A ground-floor shower · design review G-07, ageing in place · three positions compared · Taif / Palm House V8.1 · STUDY ONLY

DEFERRED to the plumbing study by the owner (2 Nov 2026): P1 preferred, P1-lite the fallback. 2 Nov 2026 · today the ground floor has the family WC, the guest WC and the maid bath (the only shower, the maid's) · a level walk-in shower ≥ 0.9 × 1.2 m, a 1.5 m turning circle where possible, access from the family side, a drain to a stack, ventilation, privacy · nothing in the design files changes until the owner decides · all sizes assumed

P1 · the family WC and the family basins become one accessible wet room (recommended)

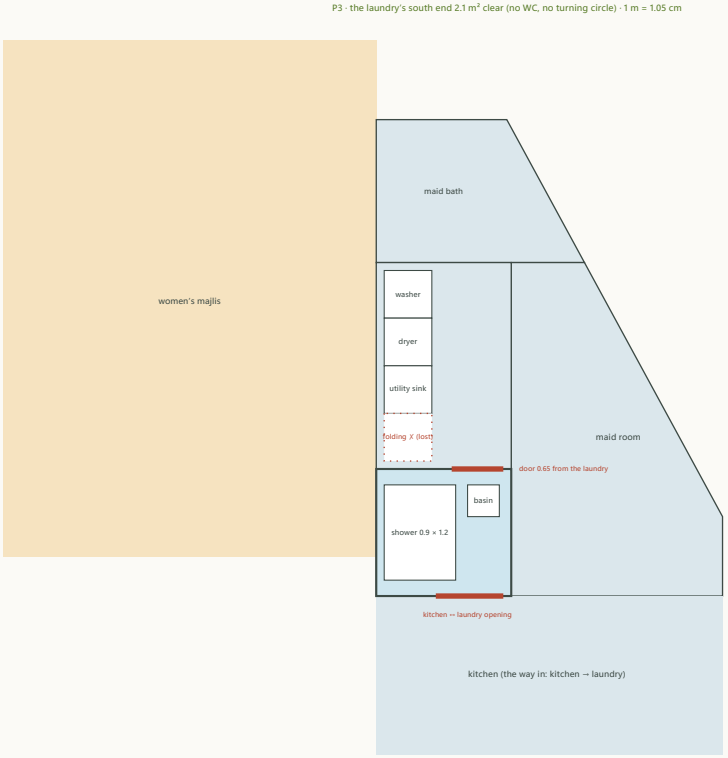
- **Where:** the west wash block, x 0–2.75, y 12.9–16.1: the two rooms merged by removing the wall on y 14.4; **2.53 × 3 = 7.57 m² clear**.
- **Layout:** the **wudu basin counter kept** on the north wall (two basins, 1.2 m); a **level walk-in shower 1.2 × 1.2** at the south-west corner (a fold-down seat, grab rails, a curtain or a half screen, the floor falling to its outlet: the ground slab is on grade, so the floor is lowered locally with no beam in the way); the **WC** at the south-east corner with grab rails both sides; a **1.5 m turning circle** in the middle (the level shower zone may be part of it); a **1.0 m sliding door** on the riwaq side (no swing in the 1.30 m riwaq), parking on the 1.9 m of wall south of it. Non-slip tiles, a hand shower, lever taps, a night light.

- **Access:** from the riwaq (the family side), 3 m from the lift, never through the guest side. **Drain:** the shower outlet into the west drain run under the wash block beside the existing WC stack (one run, as decided). **Ventilation:** a small west window (sill +1.8, under the first-floor bath 3's window) plus an extract fan. **Privacy:** its own door; the shower and the WC at the south end, out of the door's sight line; the basins by the door.

- **Effect on the rooms around:** the **open wudu basins** (open to the riwaq today) are now **behind a sliding door that stays open by day**: the one real loss; the hospitality kitchen, the serving passage, the utility room and the riwaq are untouched. **Structure:** the GF wall on y 14.4 carries the hidden beam **B14** under the first-floor wall between bedroom 2 and bath 3: without the wall, B14 becomes a **drop beam 0.25 × 0.45** spanning 2.75 m from the west wall to B10, hidden in the wet room's gypsum ceiling (the house rule): the engineer.

CLOSED 3 Nov 2026 (owner): not needed; no ground-floor shower. Study checks passed (7)
